REMARKS

Annotated
Title: CHILD SEAT COVER
Inventor(s): Kelly L. RUNK
Appl. No.: 10/798,895

FIG. 3

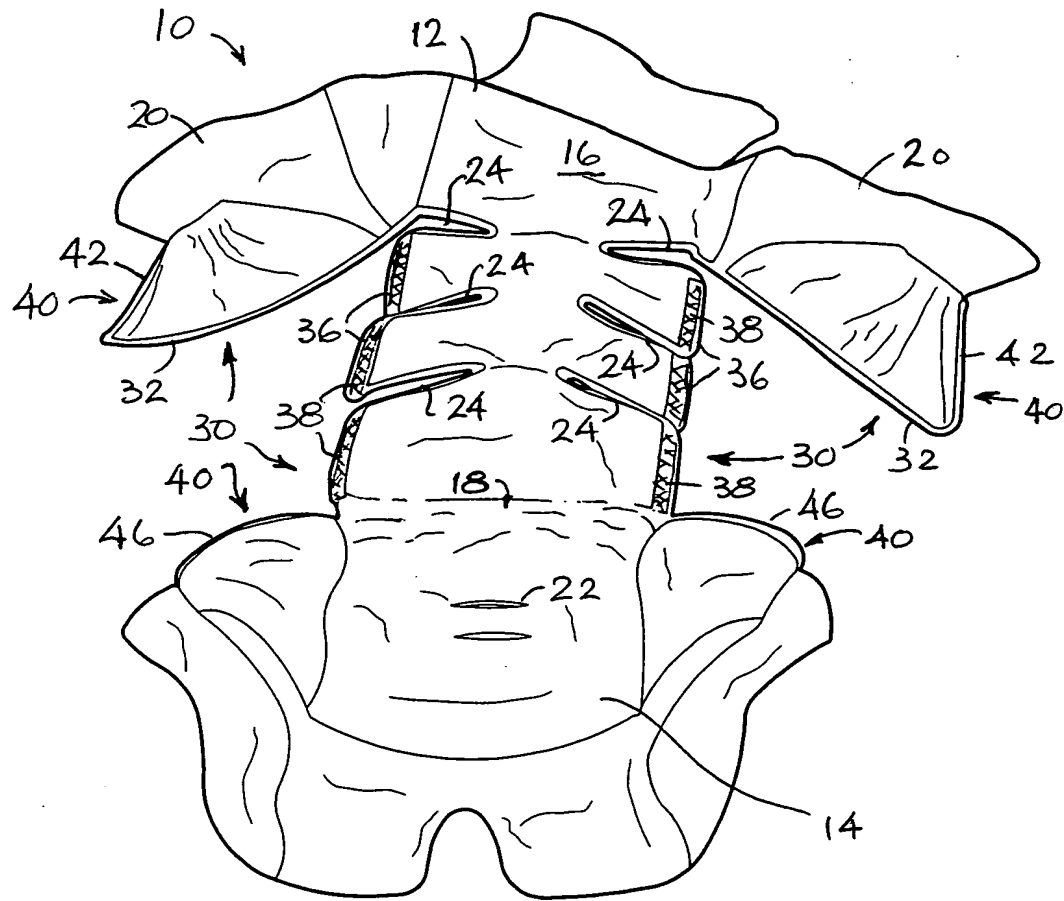
Applicant has amended Figures 3, 9, and 11 to remove the additional crotch slot so that these figures conform to the remaining figures in the application. Applicant also has amended the specification at paragraph [0024] to indicate that alternative pad embodiments can include two crotch slots. By these amendments, Applicant has merely taken the illustrated additional crotch slot and explicitly described it in the specification. Applicant submits that the amendment to the specification does not add any new matter to the application.

The drawing sheets attached in connection with the above-identified application containing Figures 3, 9, and 11 are being presented as new formal drawing sheets to be substituted for the previously submitted drawing sheets. Figures 3, 9, and 11 have been amended to remove the additional crotch slot so that these figures conform to the remaining figures of the application. Appended to this amendment is an annotated copy of the previously submitted drawing sheets which have been marked to show where the changes presented in the replacement sheets occur.
